## SERVICE LETTER #44

**SUBJECT:** Series 5 Connect Tube Threads

**APPLICABILITY:** All Series 5 Fuselage Kits shipped prior to 31 November 1994

**FIGURE 1**

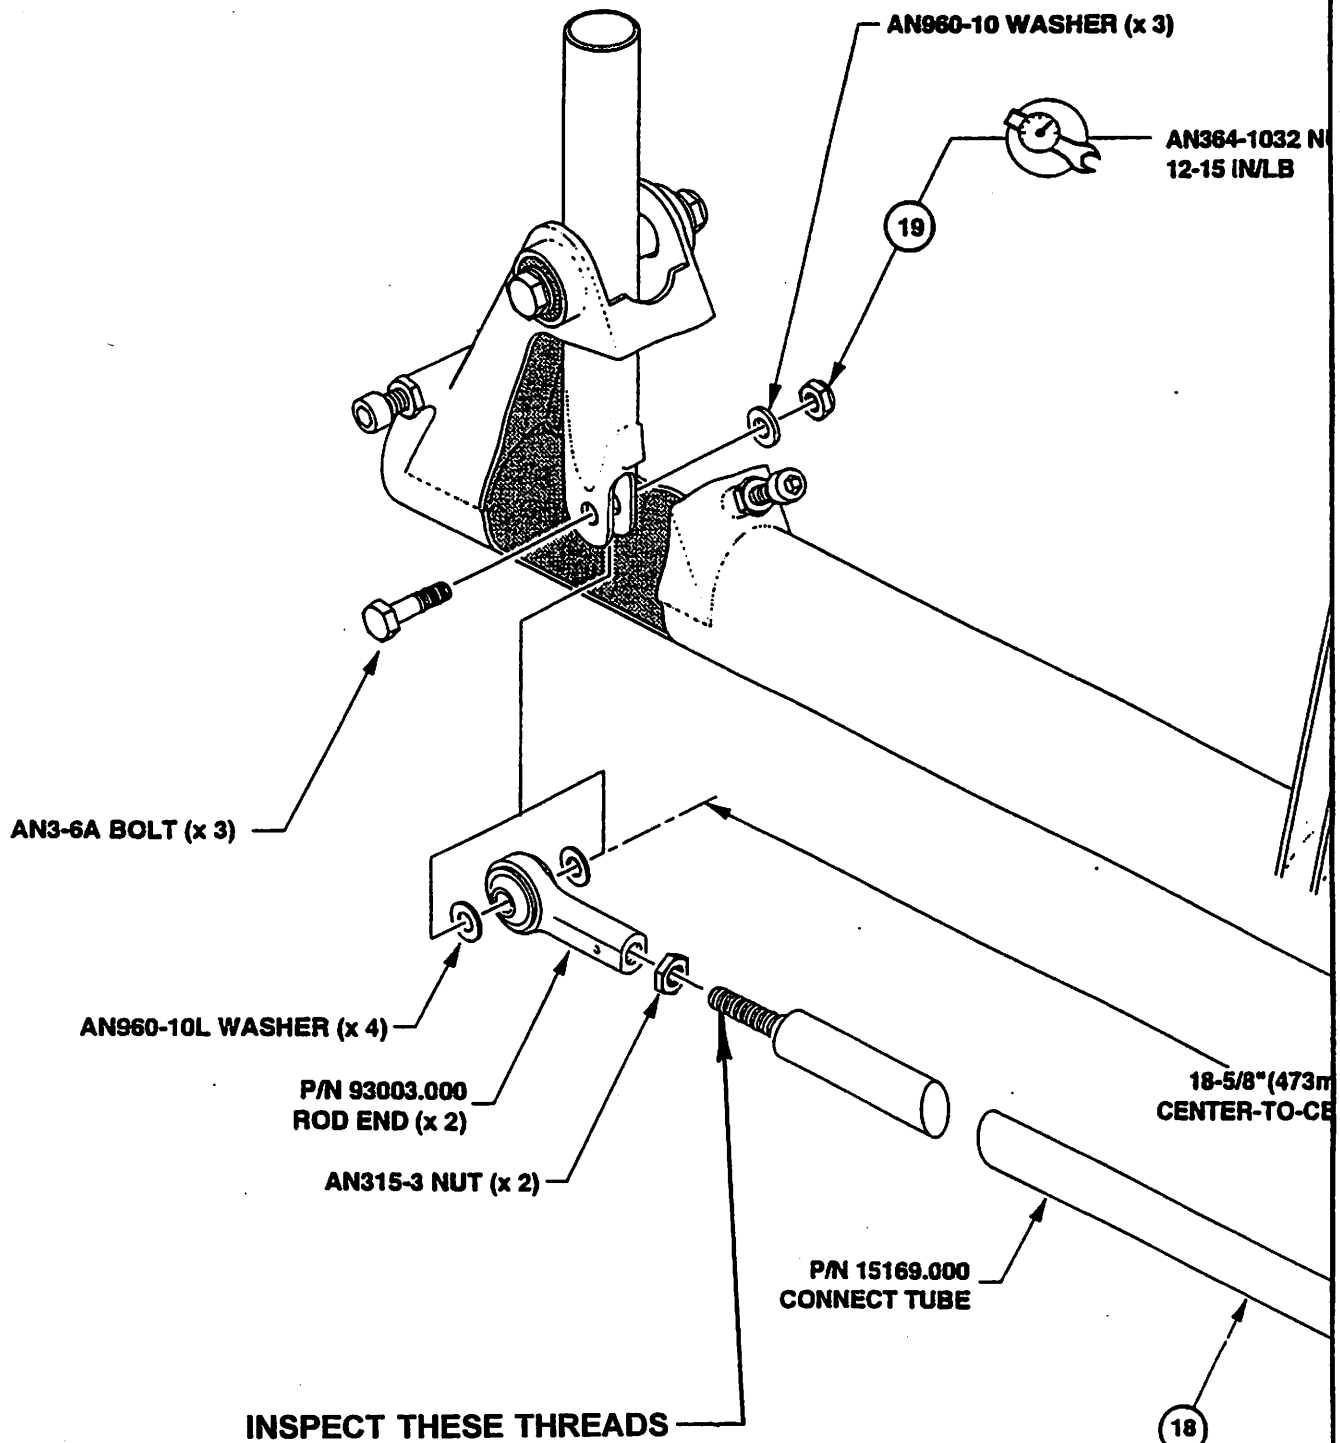
The Engineering Department recently discovered that some Series 5 Fuselage Kits were sent out in which the P/N 15169.000 Connect Tubes were inadvertently manufactured using 1/4-28 threads instead of the proper 10-32 threads. An easy way to determine which size threads your connect tube has is to take one of the P/N 93003.000 Rod Ends and try to screw it onto the connect tube (see Figure 1). If the rod end does not thread easily, the thread size on the connect tube is incorrect. If this is the case, call our Customer Service department at 208-466-1711 for a Return Materials Authorization (RMA) number. Once this number is issued, the defective part may be returned to SkyStar for a replacement connect tube.
